SECTION 4.55 (1A) MODIFICATION STATEMENT

**ALTERATIONS AND
ADDITIONS TO MERIDEN
SCHOOL (SSD-9692)**

Prepared for
MERIDEN SCHOOL
18 September 2020

Figure 4 Updated Landscape Plan

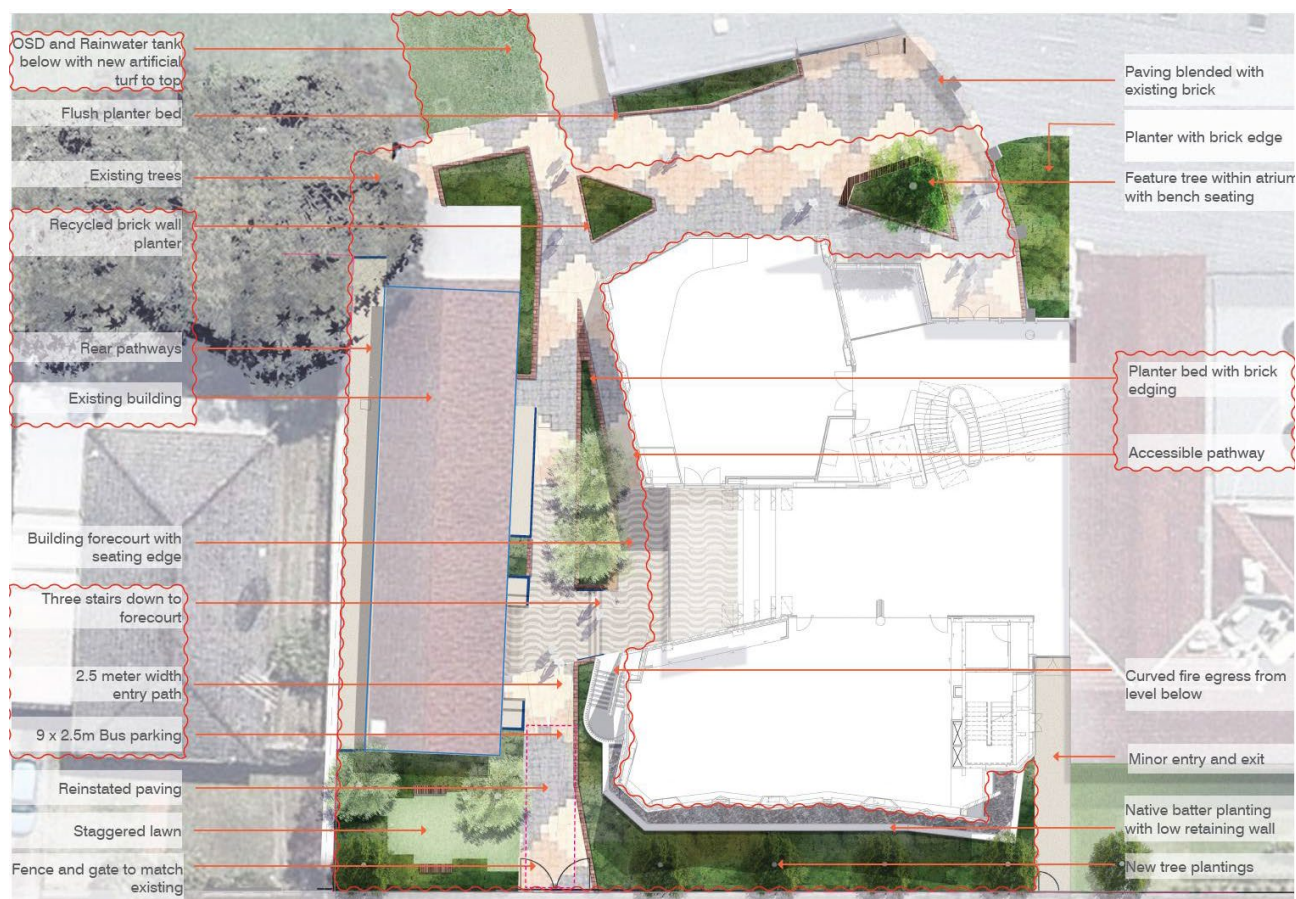
Local DA DA2014/023 approved the demolition of the staff building located in the southwestern corner of the Senior campus, and to the west of the CMD. The demolition of the building has not yet commenced, and the building is currently been used by the school. The location of the building is identified in Figure 4.

As part of further operational investigations by Meriden, it is now proposed to retain this existing building to provide teaching space for existing students and support ongoing school operation. The retained building is intended to replace the demountable classrooms to provide permanent and improved teaching space.

As a result of retention of the building, landscaping around the CMD is also proposed to be modified as approved under the SSDA.

The landscape changes only relates to the part of the senior campus located west of the CMD building. The intent of the amended landscape design is to provide landscape integration between the CMD and the reinstated staff building (refer to Figure 4). The landscape design reinstate the paving between the buildings to blend in with the existing brick.

New landscape treatment is provided in front of the staff building, which includes a staggered lawn fronting Margert Street, Bradford pear trees and Urbanite Ash trees to retain the landscape outlook along the streetscape.

Figure 5 Updated Stormwater Management Plan

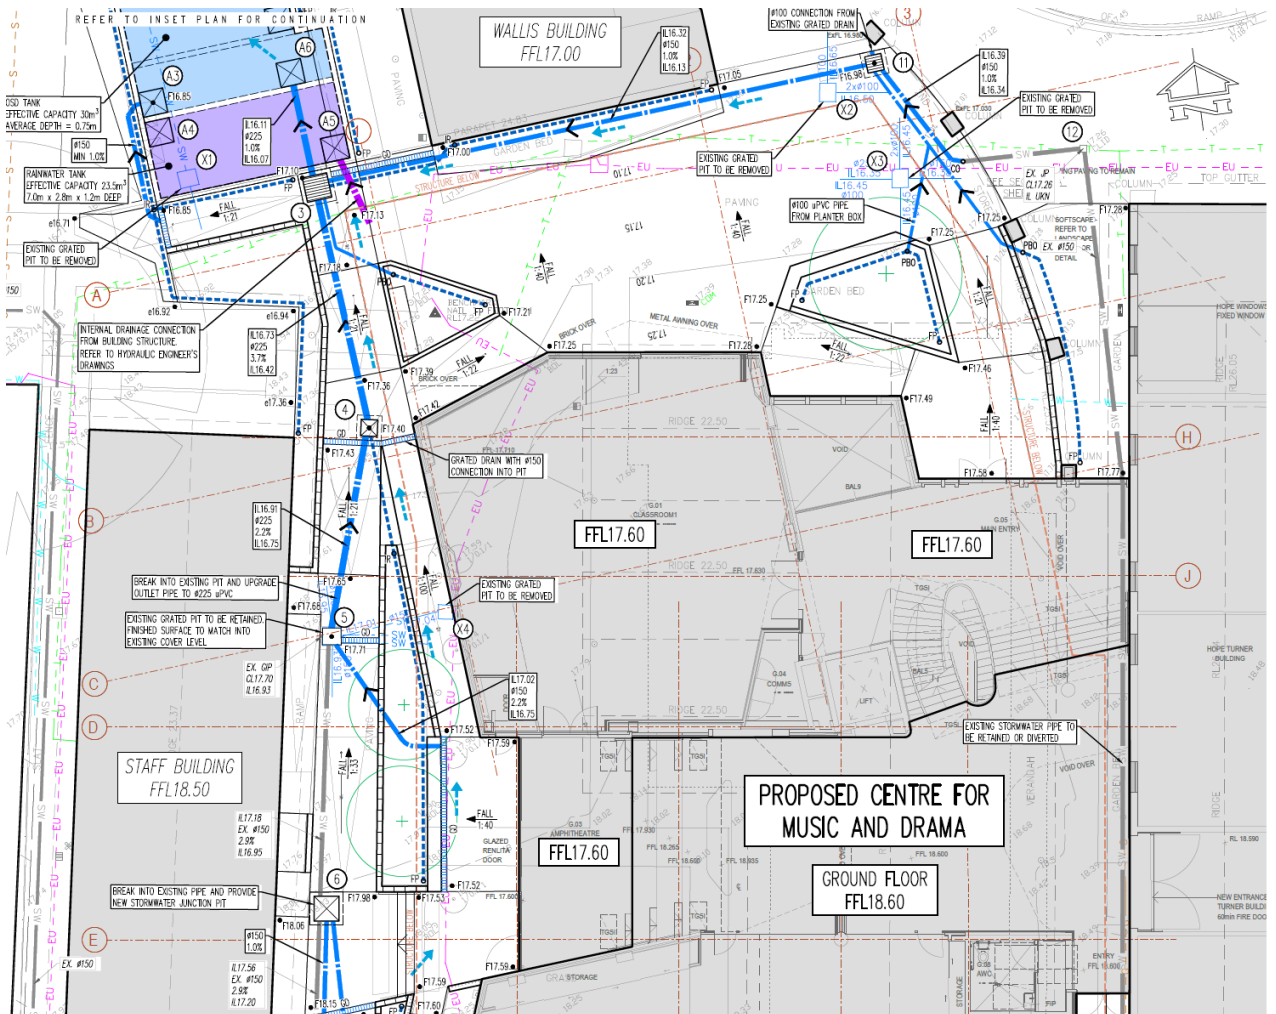
As the result of retention of the staff building and deep soil landscaping reduction, a new 30m³ On-Site Detention (OSD) tank is proposed towards the rear of the CMD building to facilitate stormwater discharge in accordance with Section 4.2 of the Strathfield Stormwater Management Code (1994).

The approved rainwater tank has also been relocated next to the OSD tank as a result of the detail design change post approval. The rainwater tank and OSD tank are proposed to be located below ground level and covered with artificial turf.
